Rotherhithe to Canary Wharf River Crossing

Value Engineering

Transport for London

04 October 2018

OPTION A: COUNTER WEIGHT INFILLED WITH CAST IRON BILLETS

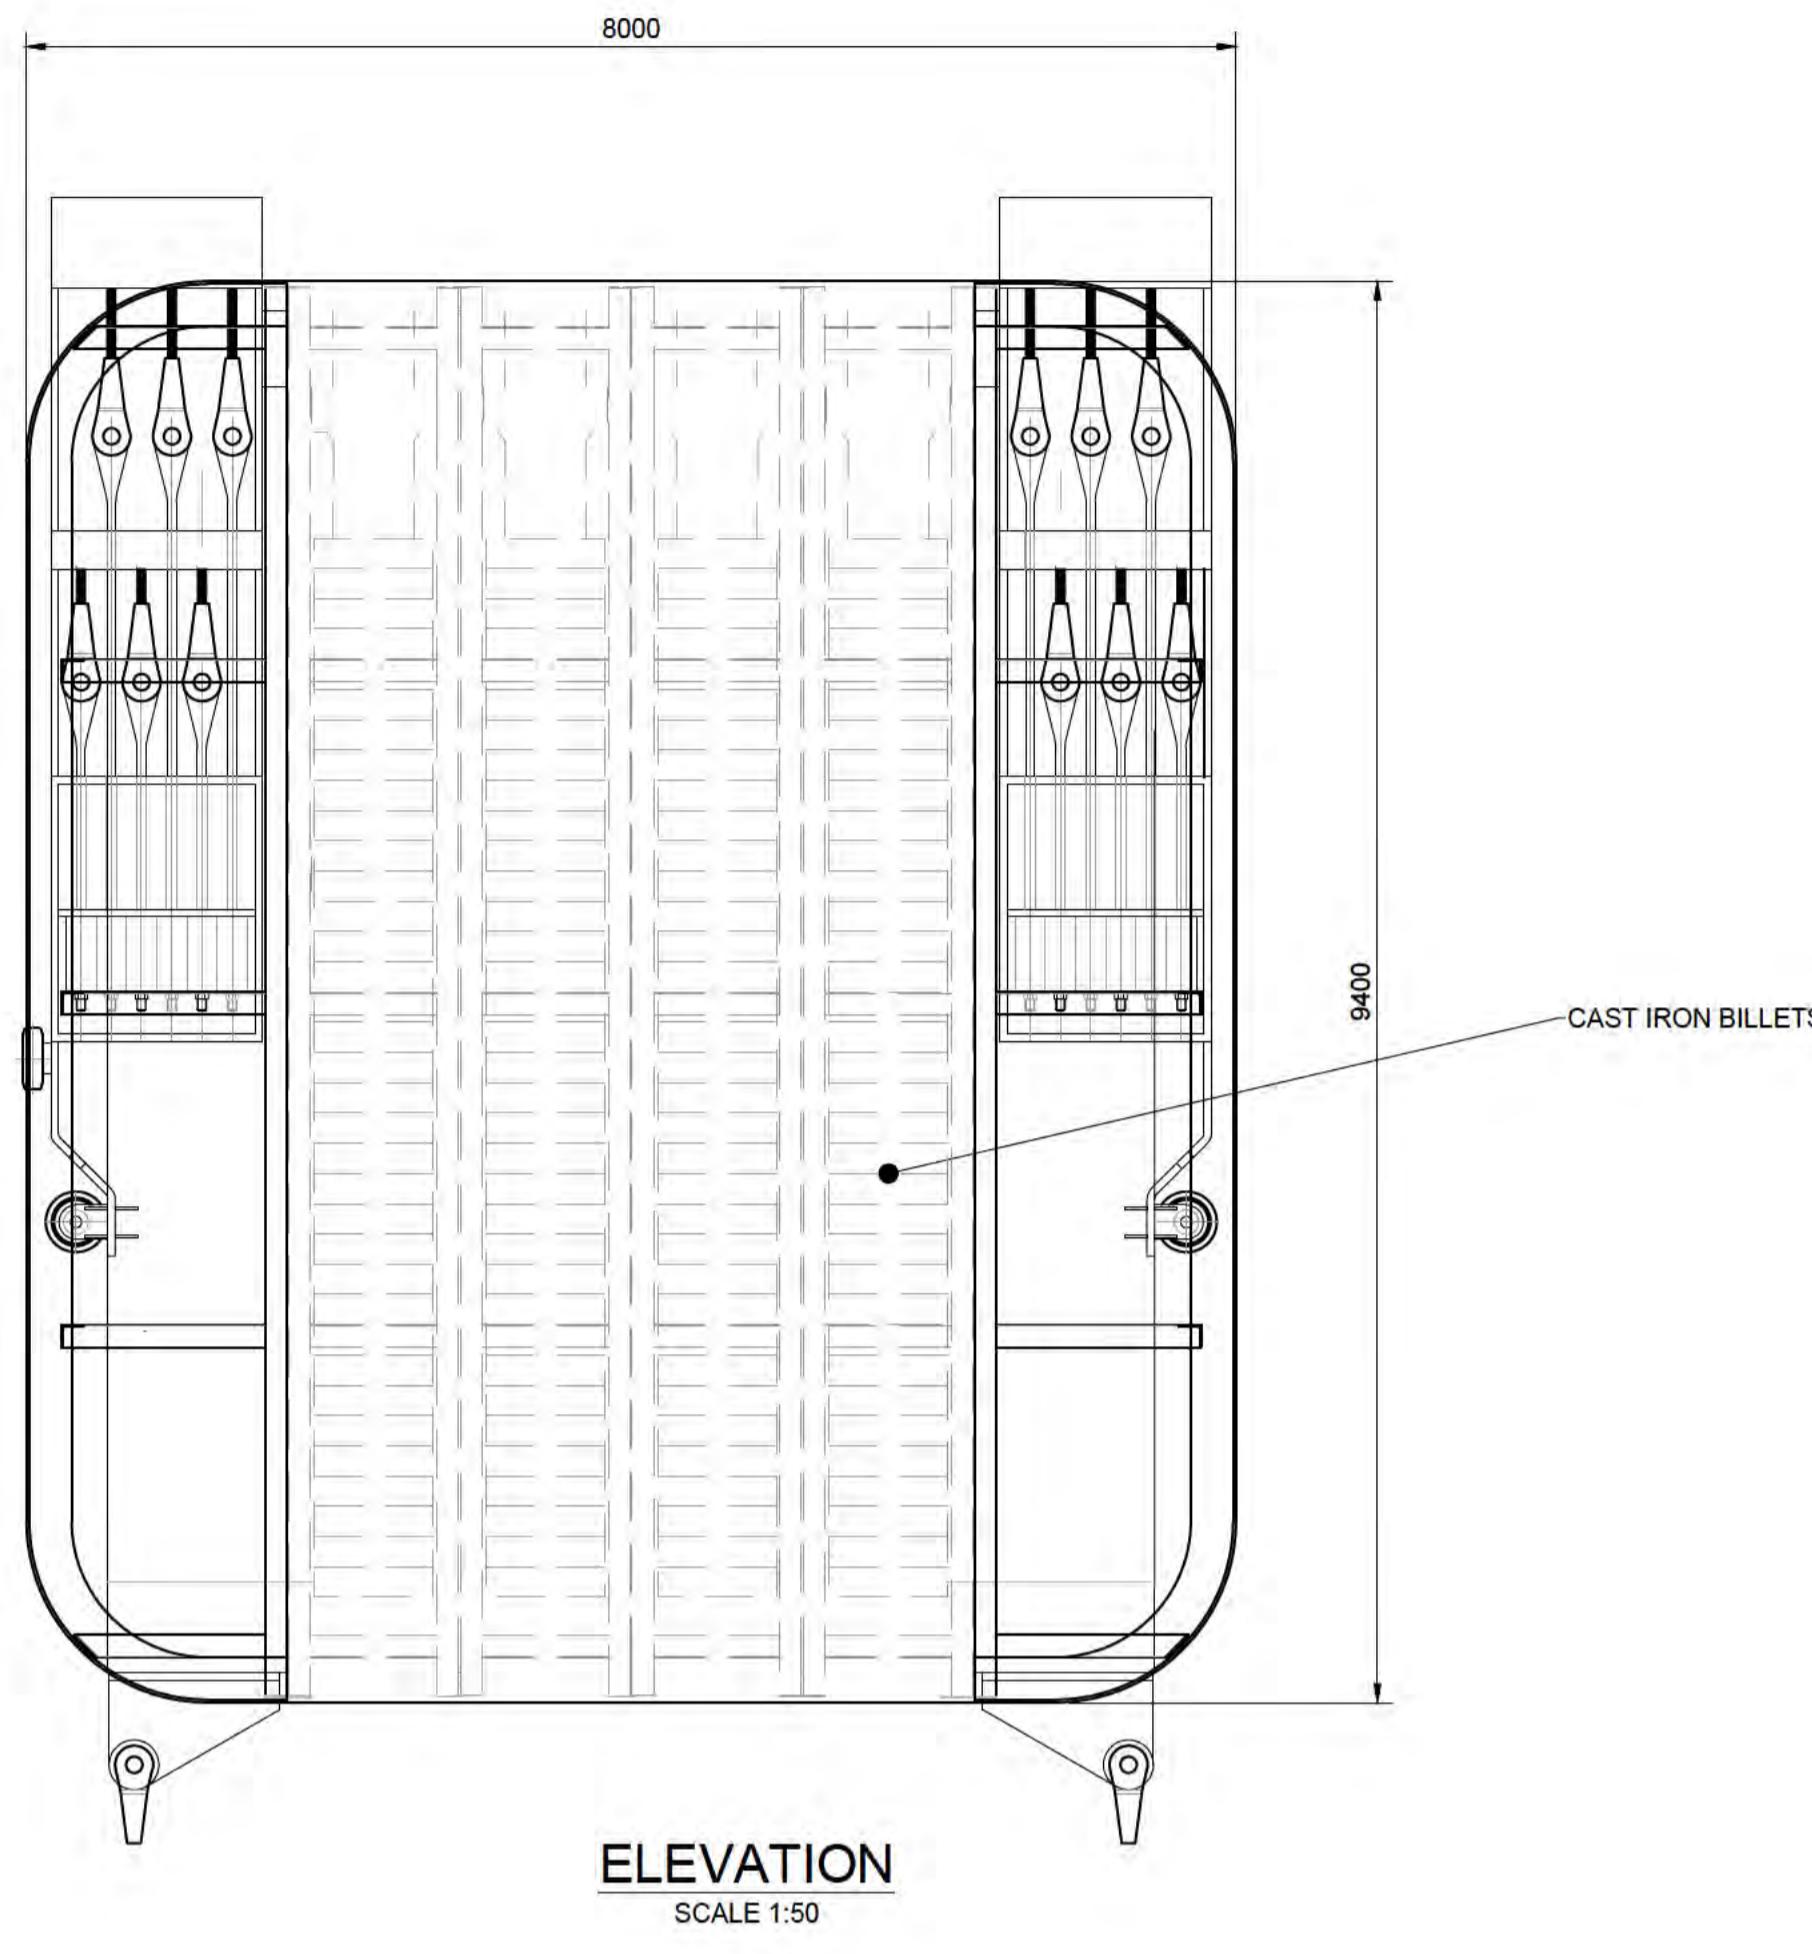
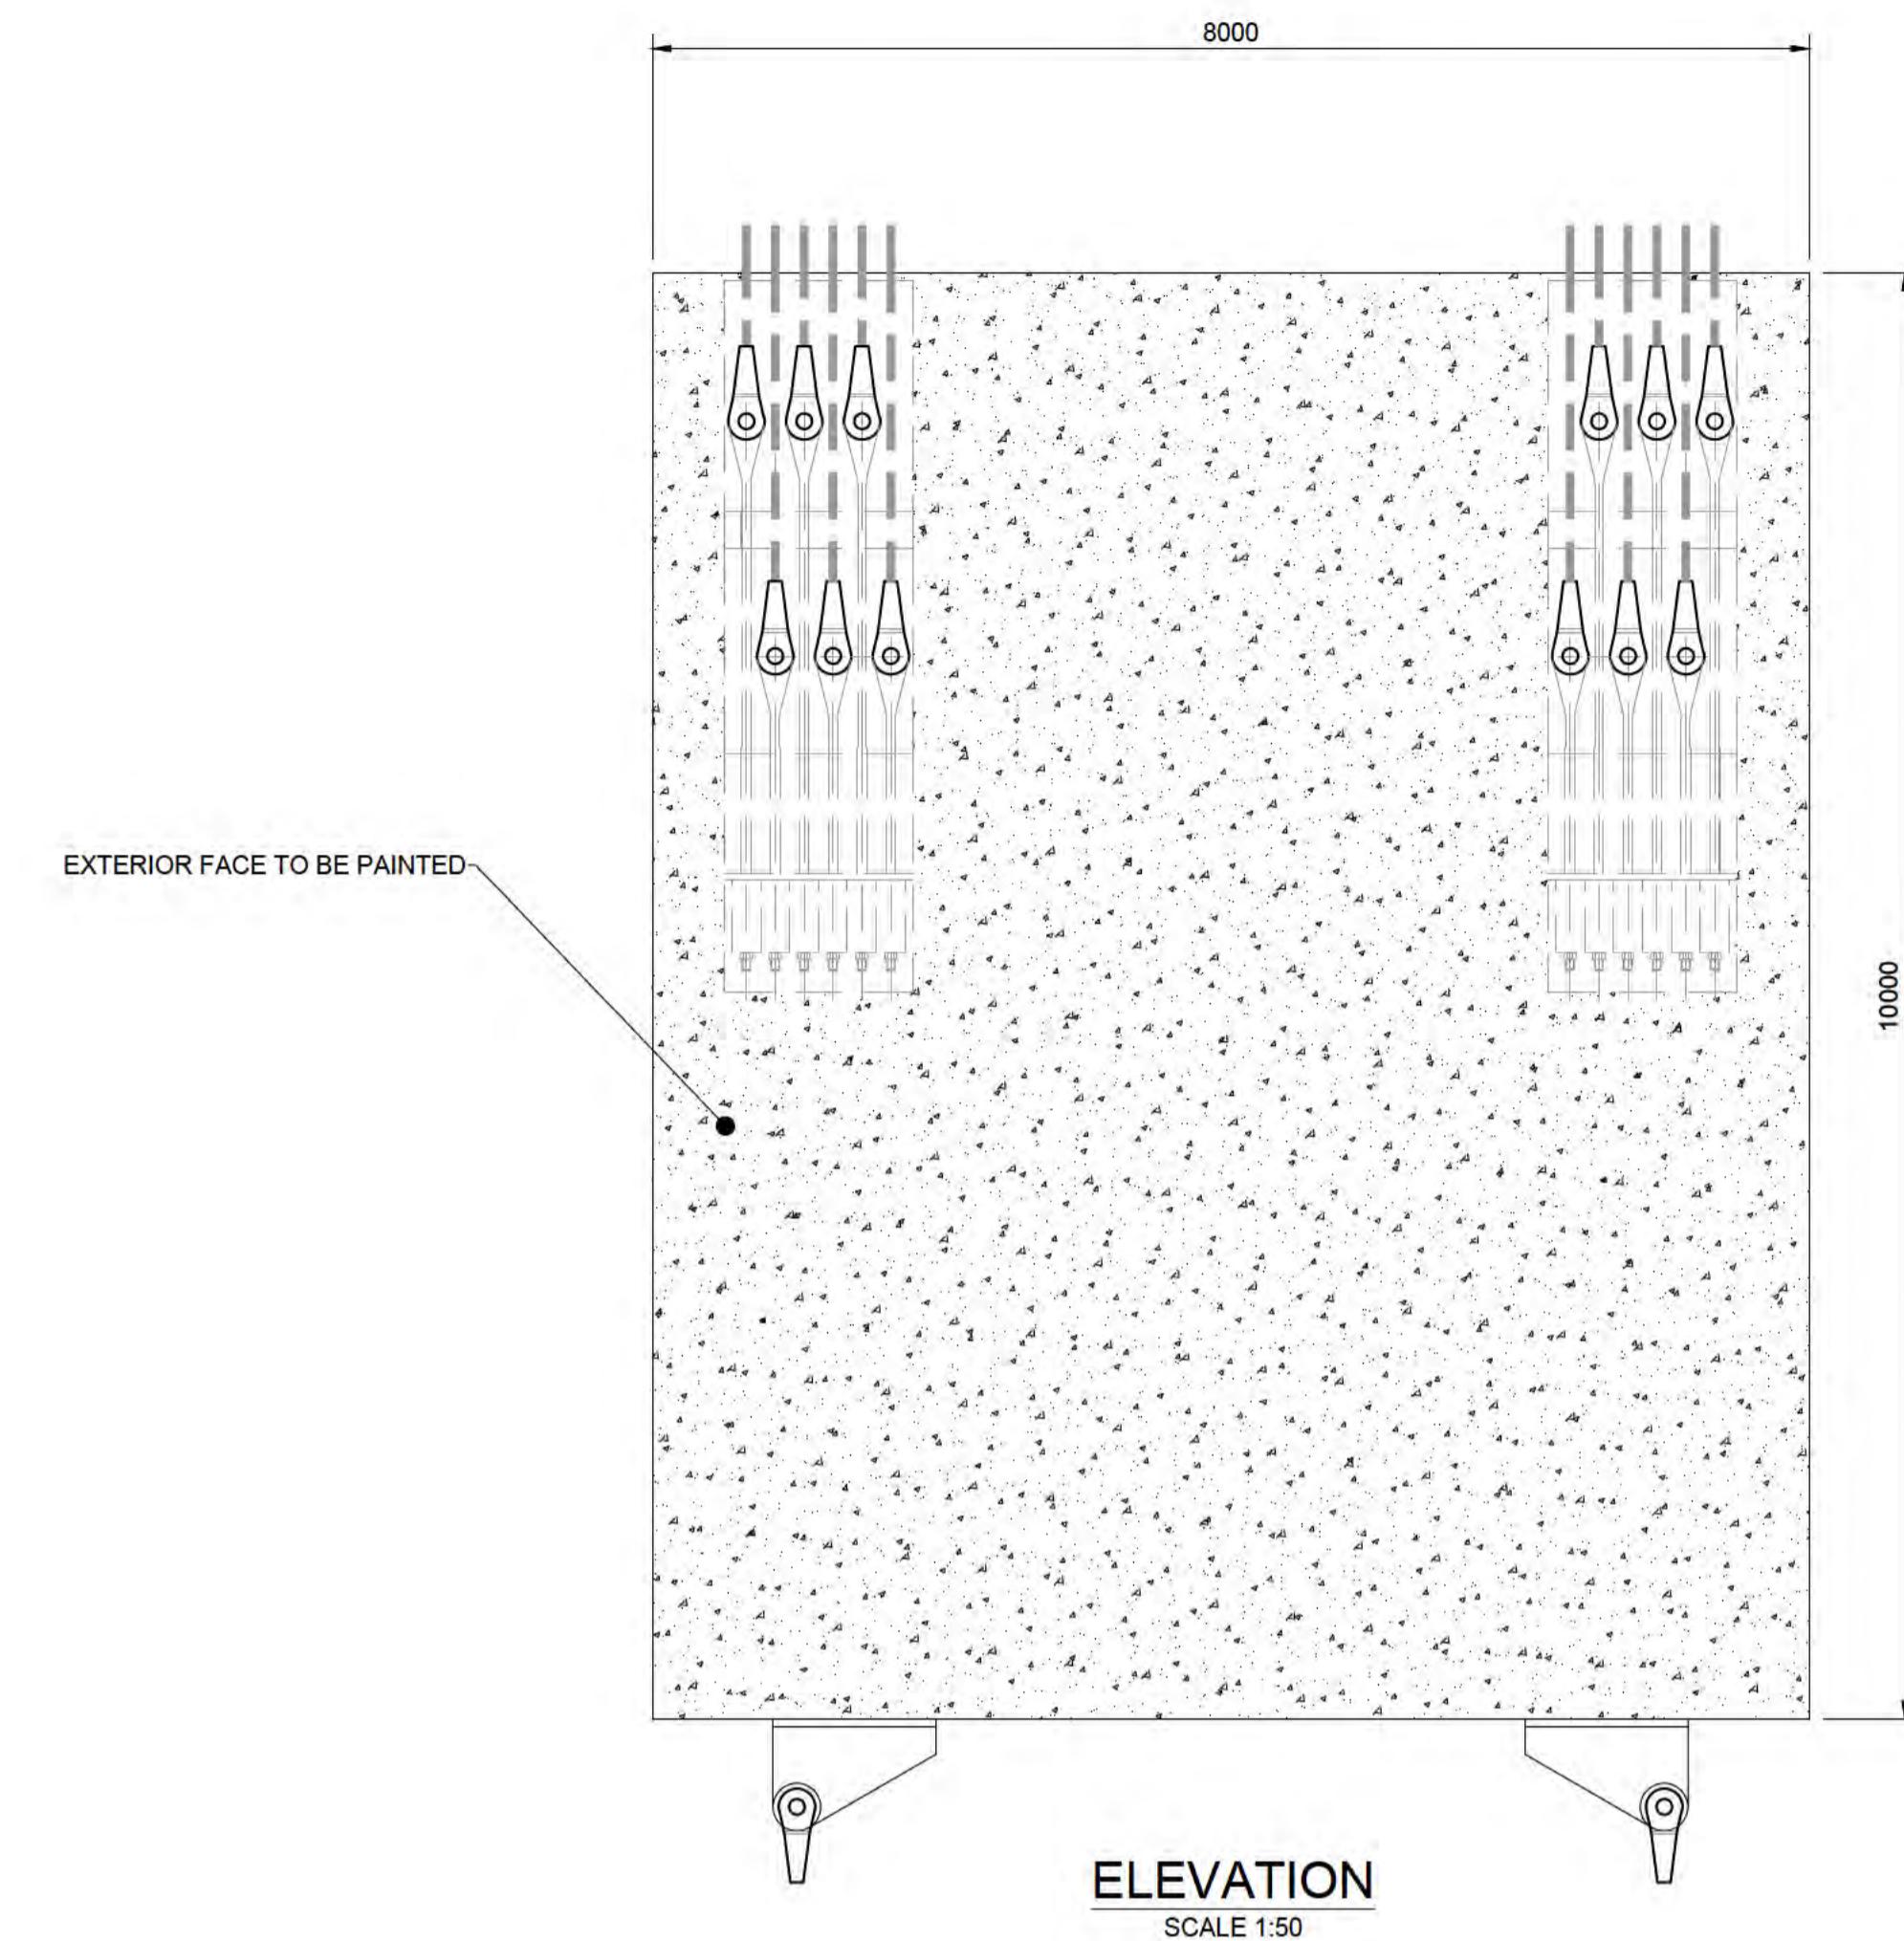
Normal grade concrete: - is not considered in the VE proposals, as it requires the height of the counterweight to be increased by 3 times (due to restriction in plan dimensions). Increasing the height of the counterweight reduces the displacement between lifted and lowered position of counterweight. Increasing the height of the counterweight by 3 times requires the height of the tower to increase to achieve the required displacement for the lifting span.

Figure 1 - Steel Plate Girder (with K-bracings & concrete deck) – alternate option to box girder

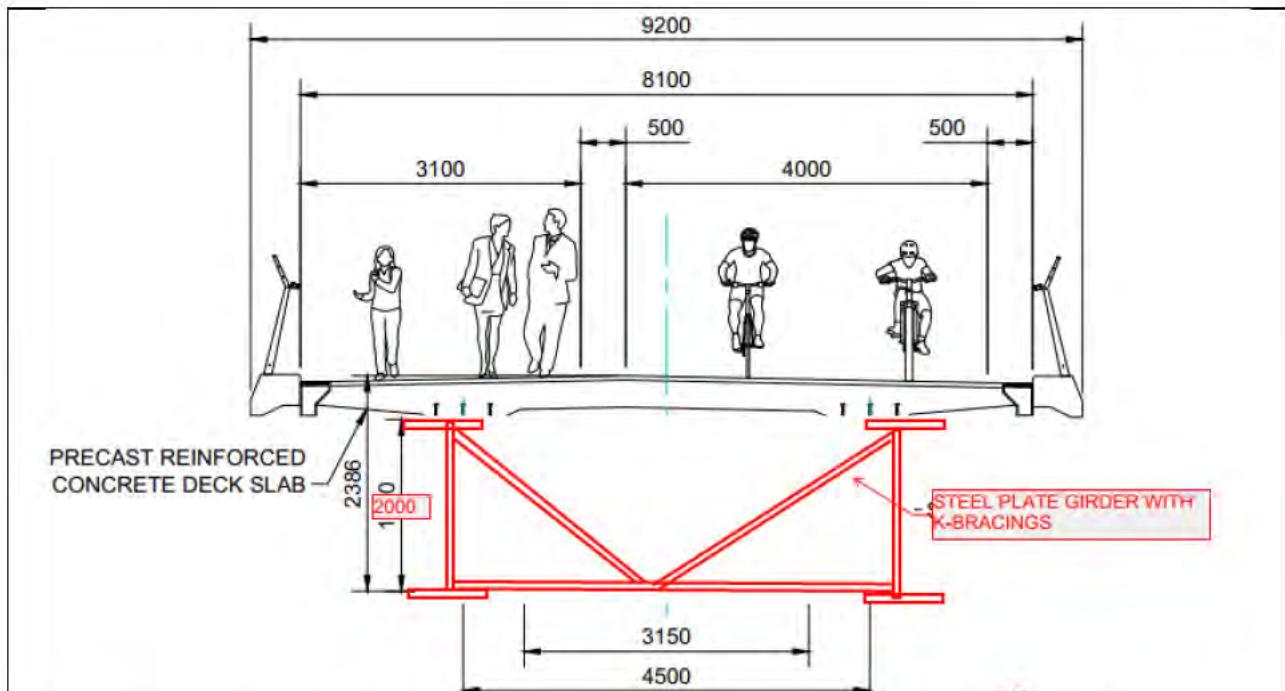
The alternate option to steel box girder for approach span is Steel plate I-girders stiffened with intermediate K-bracings (say 2.5m approx.) as shown in below Figure 1. The approximate quantity of steel for the I-girder option is 266 kg/m² (nearer to steel box girder quantity). The key advantage is significant reduction in fabrication costs compared to steel box girders although material costs are same, and the disadvantage is it is not visually appealing to the surroundings. This needs further investigation and discussion with the client and contractor about the feasibility and costs savings.

Figure 1 Tower cross-section showing the proposal to remove access elevator located inside the tower

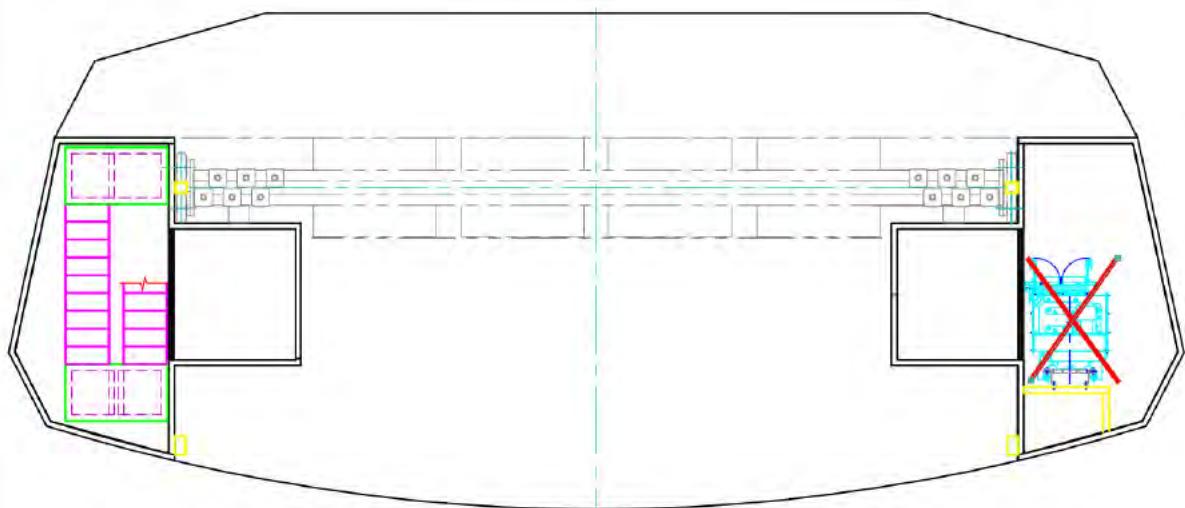
In VE31, it is proposed to remove the two maintenance access elevators located within the main span towers.

Maintenance access stairs are already proposed on other side of the tower; it is proposed to retain the elevator shaft but replace the elevator with a motorised hoist / winch. The hoist / winch would allow equipment to be moved within the pier. It would also allow the emergency evacuation of an injured person but avoiding the need to use the staircase. Safety concerns involved are access to the steel wire ropes, spragging beams on lift shaft tower for periodical inspections and it cannot be achieved with motorised hoist / winches.
